SERVICE BULLETIN

No. 425

Piper Aircraft Corporation

Subject: Replacement of Wing Spar Center Section Bolts

Carry Through Spar Assembly
(Refer to Detail "A" below)

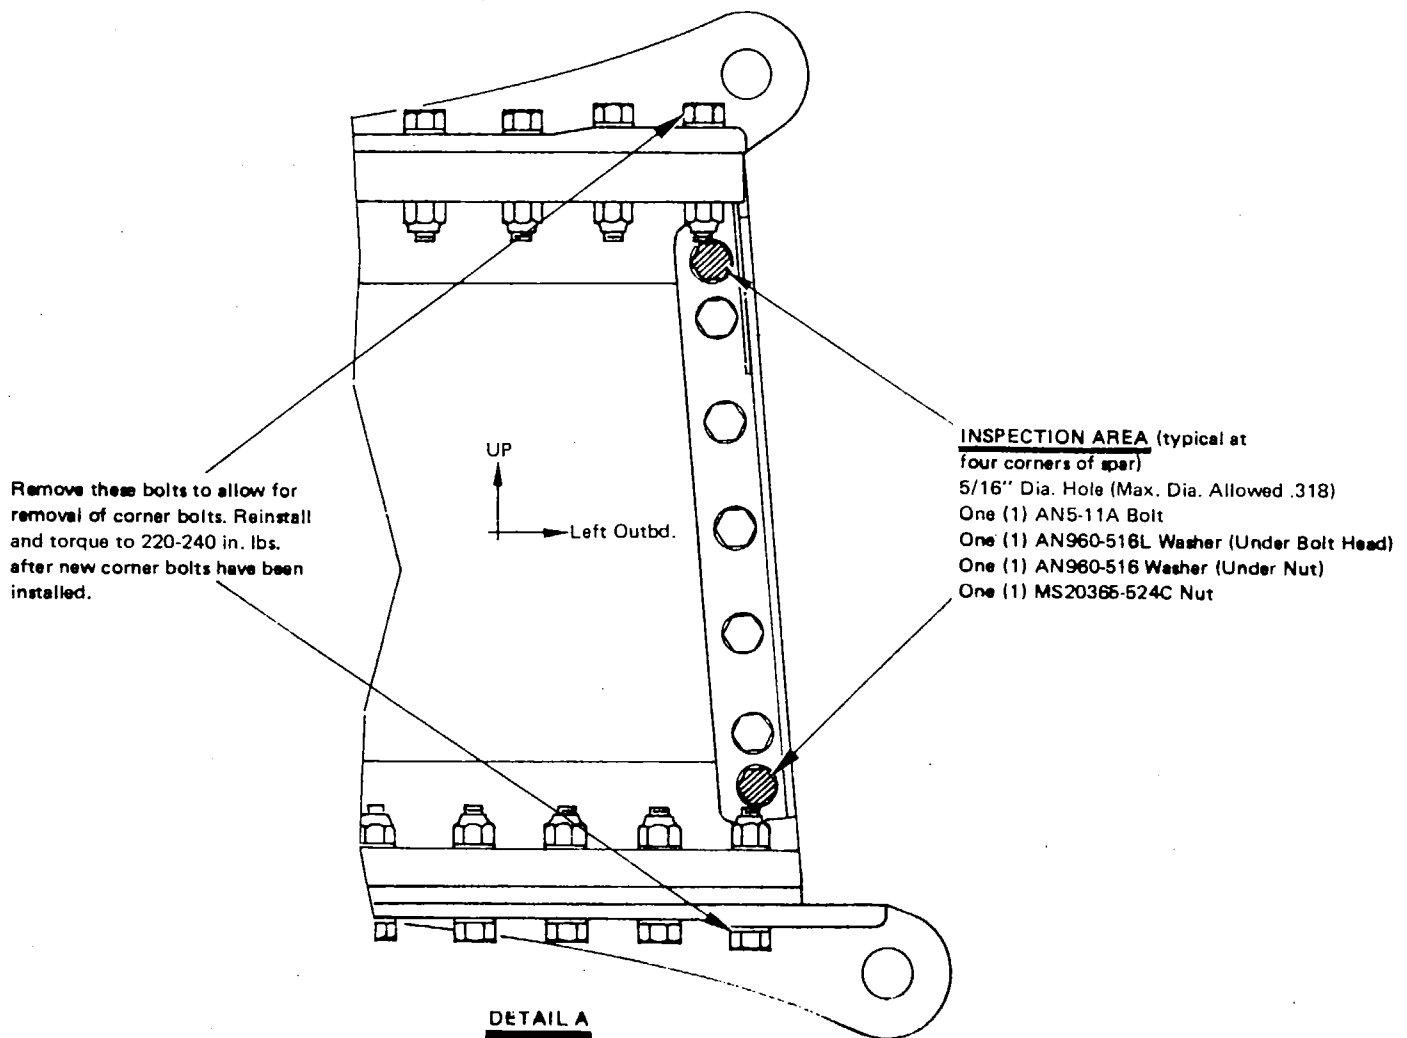
1. Remove four bolts from corners of center section. (See Detail "A") Discard these bolts.
2. Inspect and record size of each of the four corner holes.
3. Enlarge these four holes to $5/16" + .005 - .001$ Dia. **NOTE:** If a maximum hole size of .318 does not eliminate evidence of elongation or wear, contact Customer Services, Vero Beach.
4. Install hardware supplied in Kit 760 871V and torque to 100/140 in. lb. at nut.
5. Return Service Release Compliance Card with record of hole sizes.
